SUBJECT: MEETING SUMMARY - WATTS BAR UNITS 1 AND 2

This letter refers to the NRC/TVA management meeting held at the NRC Region II office in Atlanta, Georgia on September 1, 1994. The meeting was held to discuss lessons learned in preoperational testing and hot functional testing, CAPs and SPs, plant status and licensing issues. Enclosure 1 is a list of the individuals who attended the meeting and Enclosure 2 is the handout information material supplied by TVA.

Enclosure 3 is material that we used in our analysis of Hot Functional Testing. We request that you review this and respond within 30 days of the receipt of this letter with your assessment of the hardware and operational issues, your plans and schedule for using the lessons learned to enhance future testing, and your detailed schedule for retests.

Figure 1

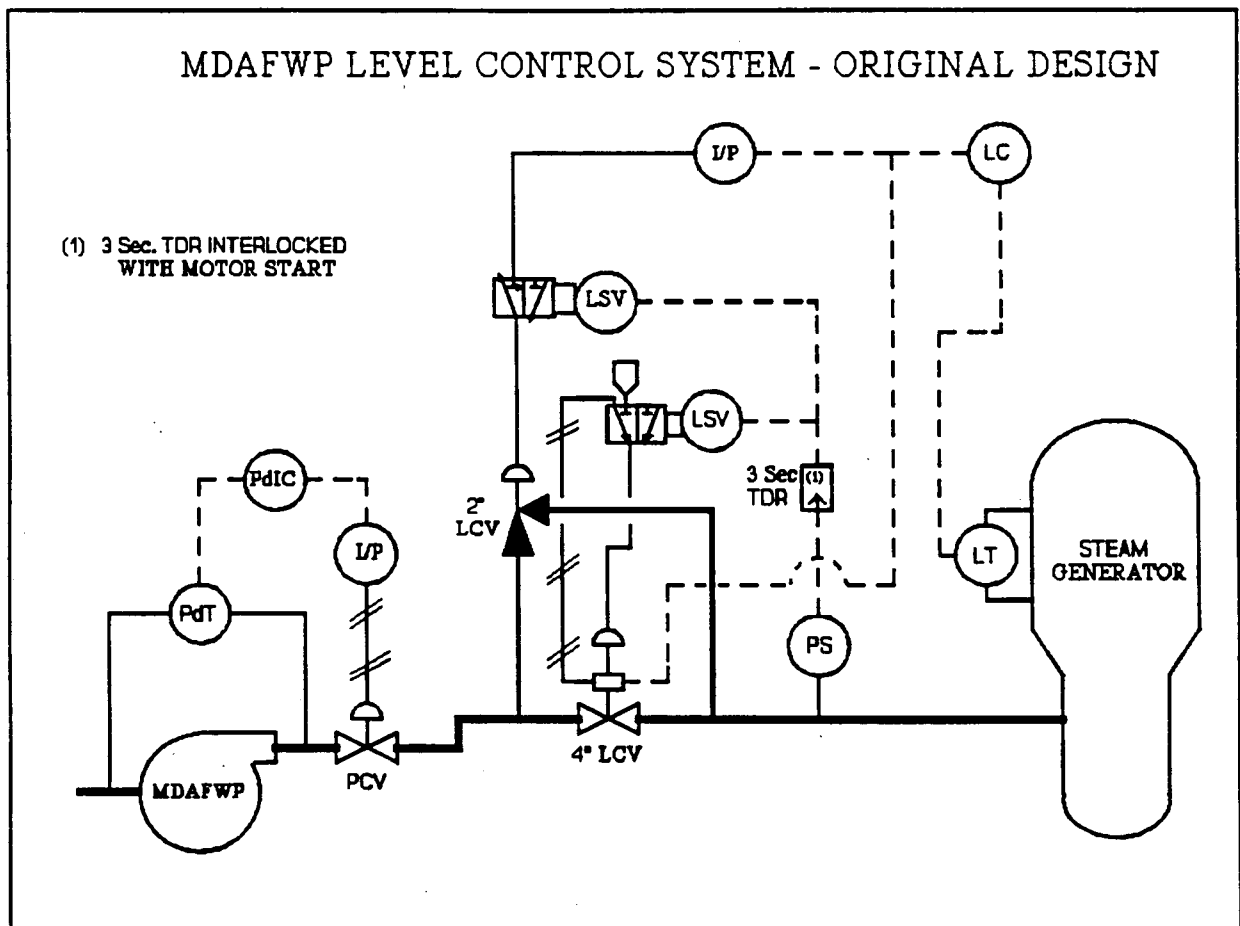
The trouble shooting of the control system by the licensee identified the following problems:

1. The level control system was unstable due to the response of the pressure switch interaction with the 2" and 4" LCV's and

2. The 4" LCV would not close when high differential pressure (approximately 1500 lbs) existed across the valve. The resolution of this issue is still pending.
3. The interaction of the pressure switch, TDR and the LCV's resulted in slow response time for the MDAFWPs. This longer time for the MDAFWPs to deliver design flow rates exceeded maximum times specified in the design output documents.

The licensee is implementing a design change that splits the range of the 2" and 4" LCVs. The design modification will change the sequencing logic, reduce the pressure switch set point to sense a faulted steam

This modification will require that the control system be tested over the expected range of operation, including response time and at steam generator pressures in the high, medium and low ranges.

Figure 2

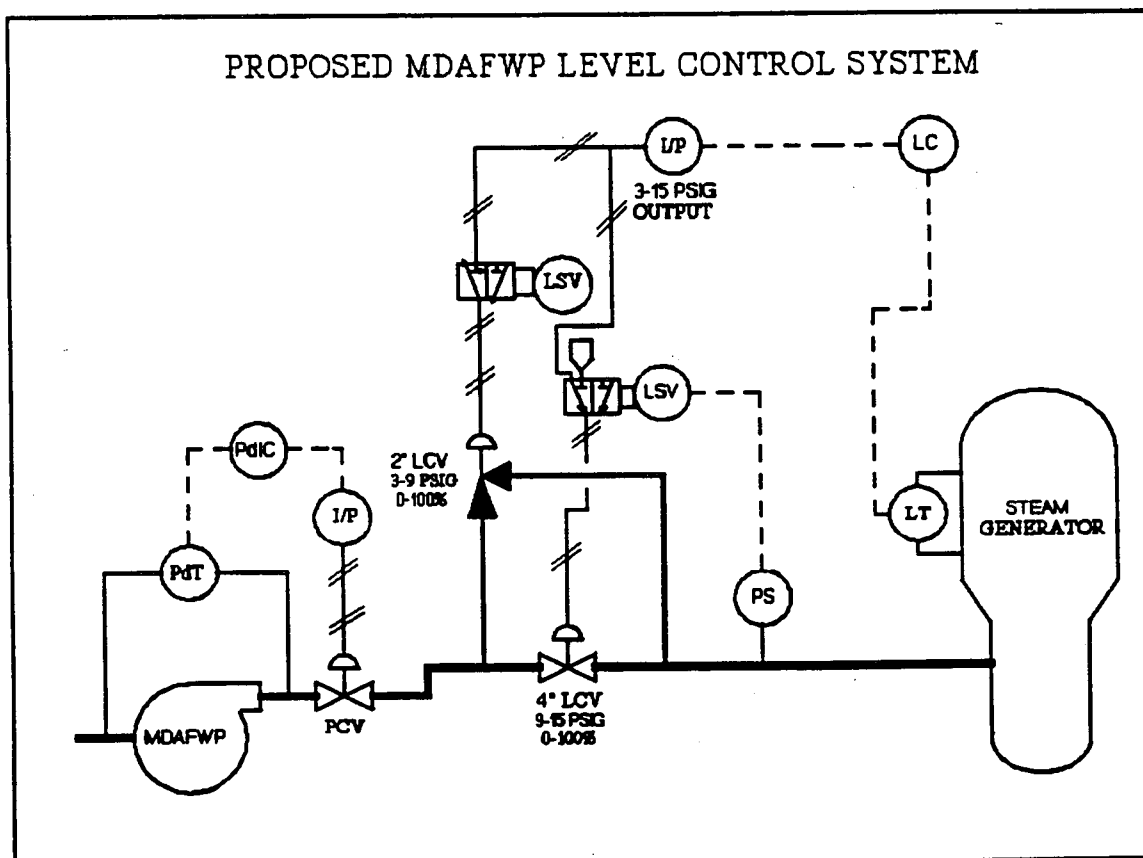
Since The 2" and 4" valves alternate opening in response to the downstream sensed pressure switch, and the action of the valves along with PCV interaction causes sensed pressure to change, this may be indicative of a inadequate review of the design for this system.

generator and provide an isolation signal to the LCV. The new modification will only opens the 2" valve at low SG pressures, and as pressure increases the 4" valve opens.
